**Requirement of connection ends of web stiffeners
in CSR BC Rules Ch.6, Sec.2-4.1.3**

1. Summary

Fig. 3 Slanted web stiffener

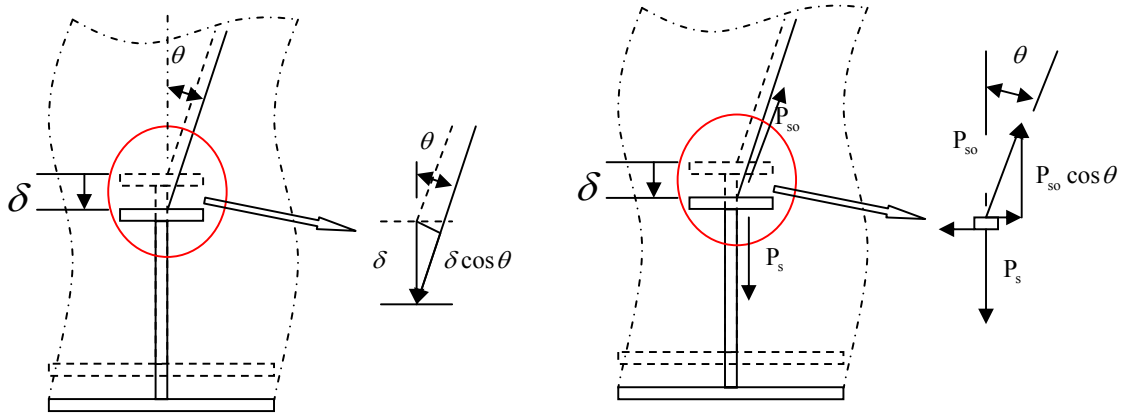
By considering correctly the effect of inclination of web stiffener, the equation of stress range ($\Delta\delta$) in CSR BC Rule Ch.6, Sec.2-4.1.3 should be changed to Eq. (12) below.

When the ordinary stiffener with a slanted web stiffener is deflected downward δ as shown in Fig. 3, the web stiffener is elongated by δ_s as follows:

The above differs from Eq. (2a) as to $\cos^2 \theta$. This effect is to be taken into account in calculation of P_s . Substitution of Eqs. (2a'), (2b) and (2c) into Eq. (1) gives

$$\Delta \sigma_s = 2 \frac{P_{s0}}{A_{s0}} = 2 \frac{P_s}{A_{s0}} \frac{1}{\cos \theta} = \frac{2W \cos \theta}{A_{s0} \cos^2 \theta + 0.321h' \left(\frac{A_{w1}}{l_1} + \frac{A_{w2}}{l_2} \right)}. \quad (12)$$
